APPLICATION NO.	FILING DATE	FIRST NAMED INVENTOR	ATTORNEY DOCKET NO.	CONFIRMATION NO.
10/759,557	01/16/2004	Edward Eytchison	SONY-24100	8128

Office Action Summary

DETAILED ACTION

Figures 1, 2, and 5 of Cheng are reproduced below.

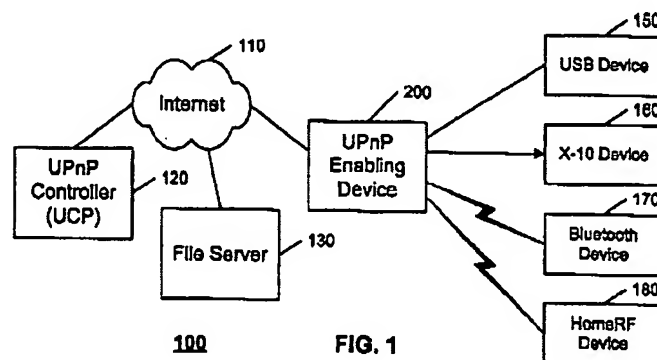
10. In regards to claims 2, 7, 12, 21, and 30 Cheng discloses, wherein the universal plug and play type device is coupled within a network of universal plug and play type devices (Fig. 1 #100 and ¶0020, teaches whereas each network is homogenous by stated that the UPnP enabling device connects multiple heterogeneous-networks.).

11. In regards to claims 3, 8, 13, 22, and 31 Cheng discloses, wherein the rendezvous type device is coupled within a network of rendezvous type devices (Fig. 1 #100 and ¶0020, teaches whereas each network is homogenous by stated that the UPnP enabling device connects multiple heterogeneous-networks.).

15. In regards to claim 11 Cheng discloses, a converter configured to couple between a universal plug and play type device and a rendezvous type device to convert communications between the universal plug and play type device and the rendezvous type device into proper formats (**Fig. 1 #200, as shown on pg. 5, and ¶0020, teaches the UPnP enabling device (converter) for converting communications for multiple heterogeneous-networks, UPnP and N-UPnP.**), comprising:

- i. c. a conversion circuit coupled between the universal plug and play type interface circuit and the rendezvous type interface circuit (**Fig. 1 #200, as shown on pg. 5.**), wherein the conversion circuit converts communications directed from the universal plug and play type device to the rendezvous type device into the rendezvous type protocol, and further wherein the conversion circuit converts

16. In regards to claims 16, 25, and 34 Cheng discloses, wherein the converter is a stand-alone device (**Fig. 1 #200, as shown on pg. 5, teaches the UPnP Enabling Device (converter) as a stand-alone device.**).

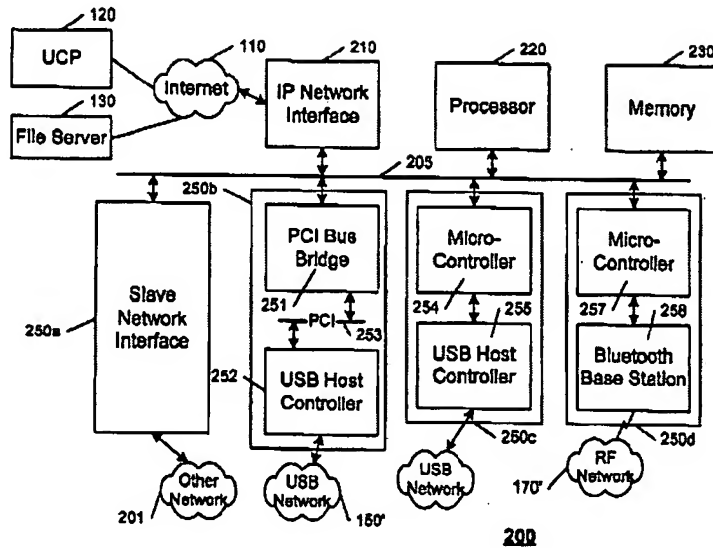
12. In regards to claims 4, 9, 14, and 39 Cheng discloses, wherein converting the communication is performed by a conversion circuit (Fig. 2 #220 and ¶0022, teaches the processor converting the communication.).

- g. a. a universal plug and play type interface circuit configured to couple to a universal plug and play type device operating under a universal plug and play type protocol (**Fig. 2 #210, as shown on pg. 6, teaches a IP Network interface used for sending and receiving UPnP protocols.**);

- h. b. a rendezvous type interface circuit configured to couple to a rendezvous type device operating under a rendezvous type protocol (**Fig. 2 #250_{a-d}, as shown on pg. 6, teaches varies N-UPnP interfaces used for sending and receiving N-UPnP protocols.**); and

FIG. 5

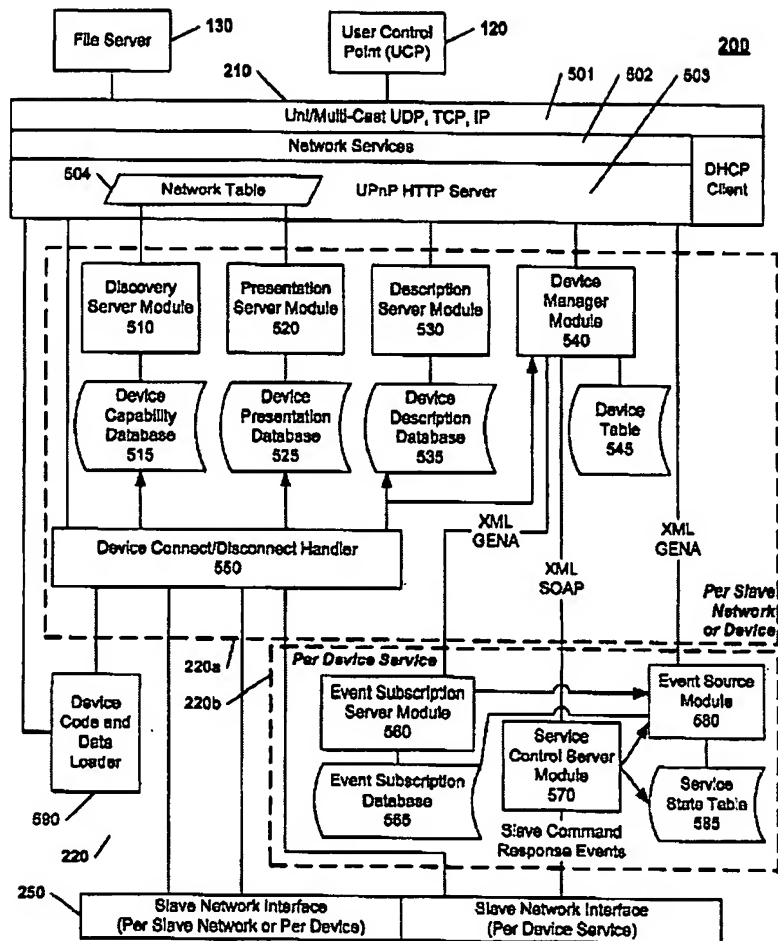
18. In regards to claims 18, 27, 36, and 43 Cheng discloses, wherein the universal plug and play type interface circuit comprises a universal plug and play type proxy (**Fig. 5 #220 and ¶0031 teaches a UPnP proxy.**) which maintains a table of entries, each entry corresponding to a rendezvous type device (**Fig 5. #504 and ¶0035 teaches a table for keeping track of each network.**).

Fig. 3 of Cho is reproduced below.

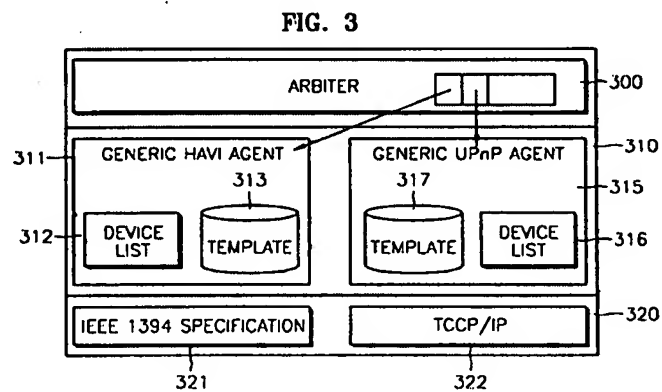
30. In the same field of endeavor Cho teaches a generic HAVI (Home Audio Video Interoperability) agent that includes a table that has entries corresponding to the UPnP devices (Fig. 3 #311 and ¶0042).

31. Therefore, it would have been obvious to one of ordinary skill in the art at the time the invention was made to modify Cheng's UPNP enabling device for heterogeneous network of slave devices with Cho's teaching as discussed above to
